**ADDENDUM NO. 002**

PROJECT:	Chelsea School District Field House – Design-Build Services
BID RELEASE NUMBER:	10
CLARK PROJECT NO:	19-2835
BID PROPOSAL DUE DATE/TIME:	<b>Wednesday, February 18th, 2026 @ 3:30 pm (ET)</b>

**Below are all pre-bid RFIs received for the Chelsea Schools New Field House Design-Build RFP.**

FLOOR PLAN  
CHELSEA ATHLETIC FIELDHOUSE

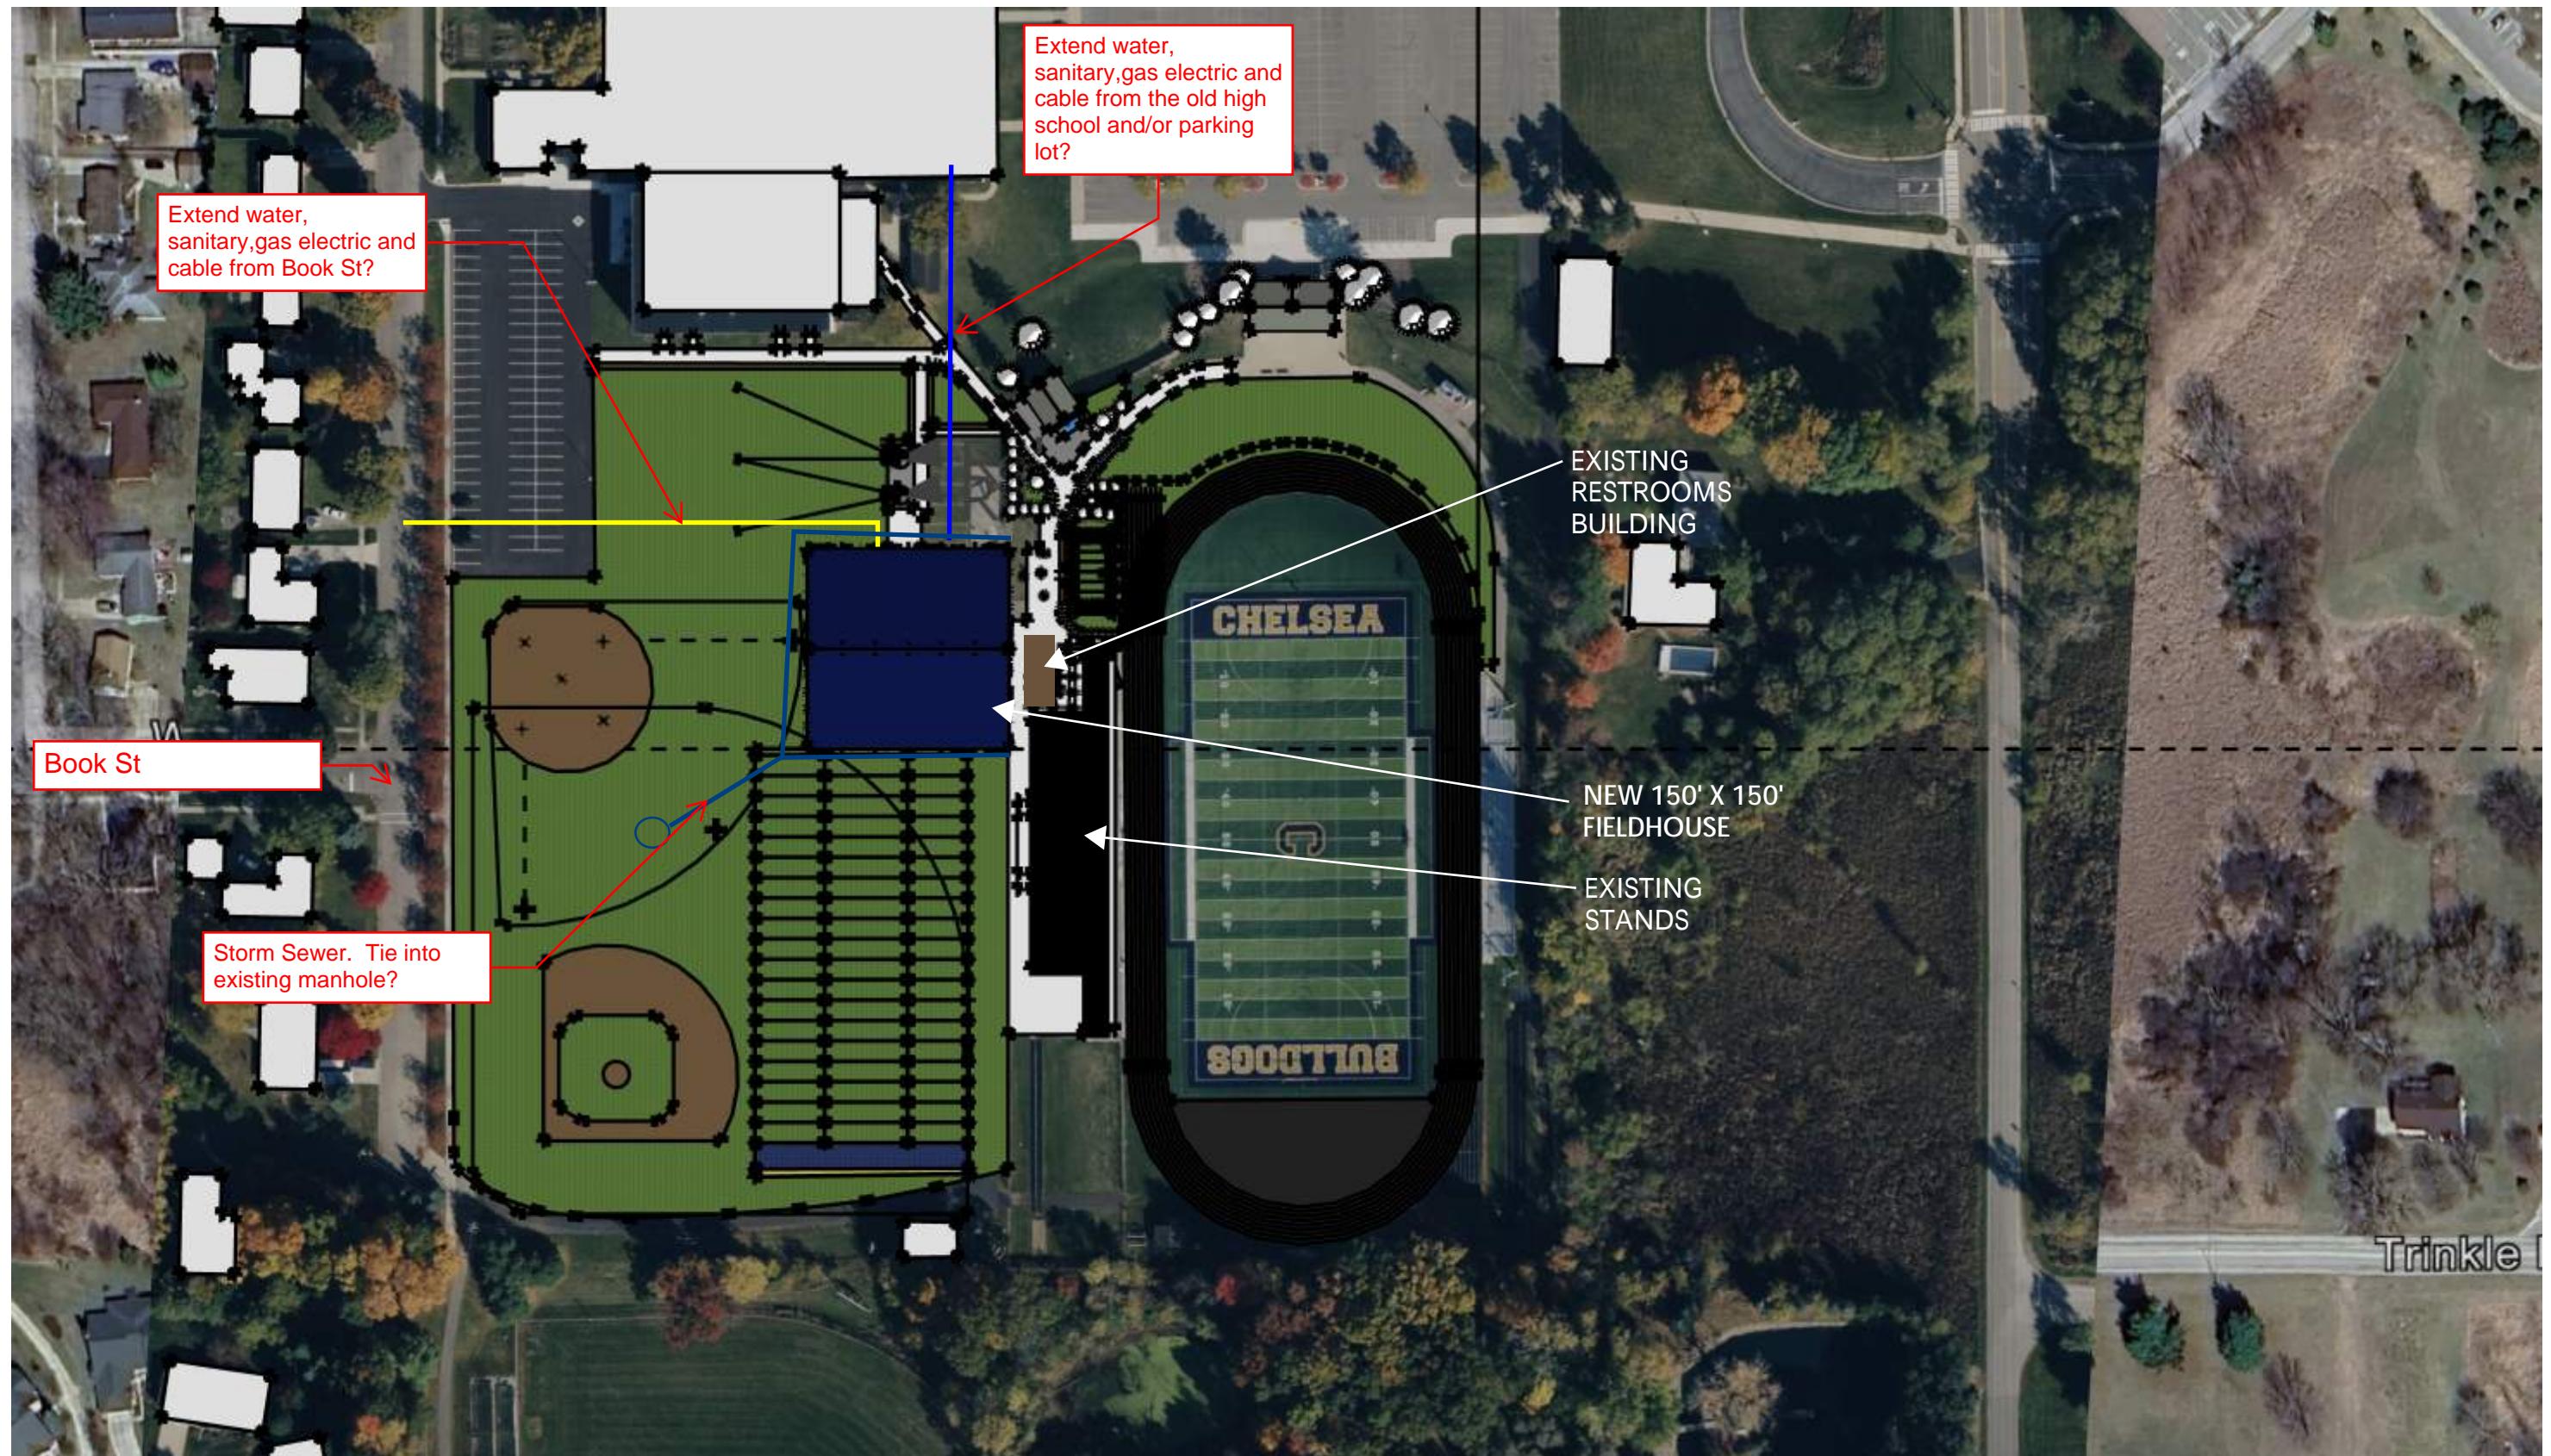
Question #22: Per the attached drawing, will the floor on the north end of the building (highlighted in red) be Astroturf or polished/sealed concrete? Will the Astroturf extend to the perimeter walls, or will the border (highlighted in green) be concrete?

**Response: Turf shall extend to areas highlighted in green and red.**

SITE PLAN  
CHELSEA ATHLETIC FIELDHOUSE

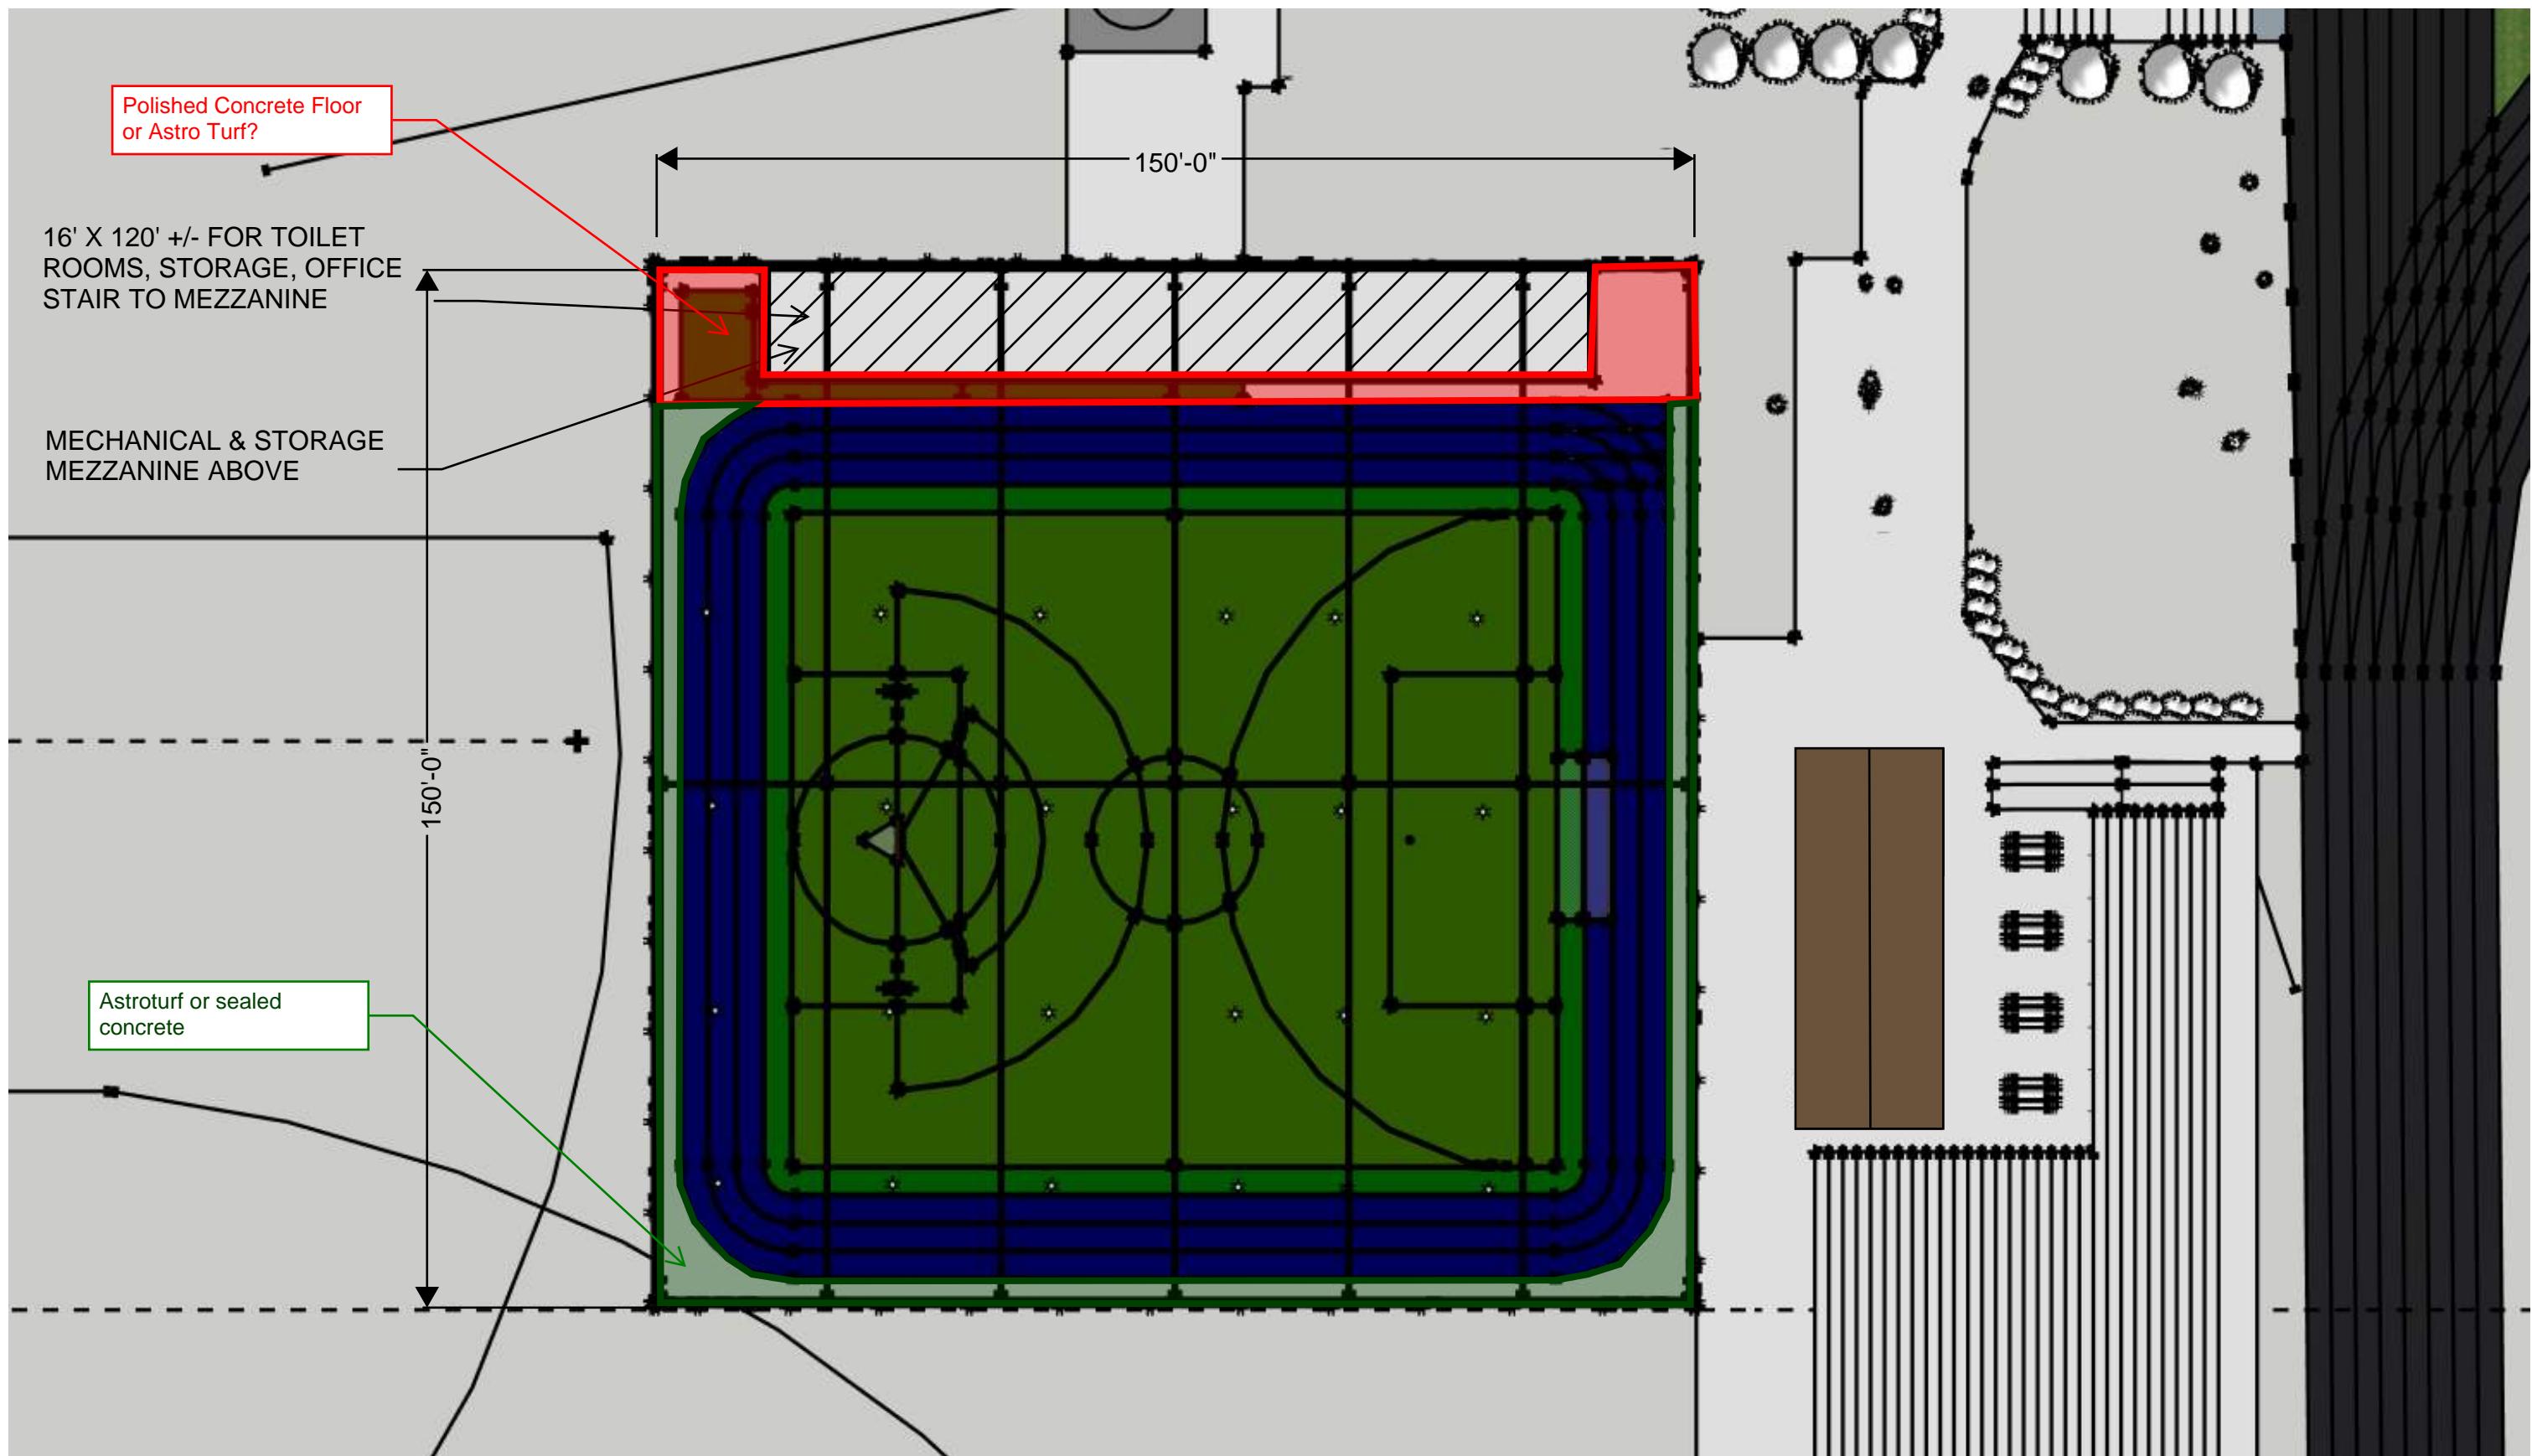
Question #21: Attached is a marked-up site plan with two (2) options for water, sanitary, gas, electric, and cable to the field house.

We checked with the City of Chelsea, and they don't have any site drawings indicating the location of the existing utilities to help clarify the issue.

- a. Should the bid be based on extending them from Book St or the old high school?
- b. Should an allowance be included for each item that will be revised after the survey is completed and the site plans are finalized?

- a. **Assume extending utilities from the old high school.**
- b. **Owner to hold the allowance.**
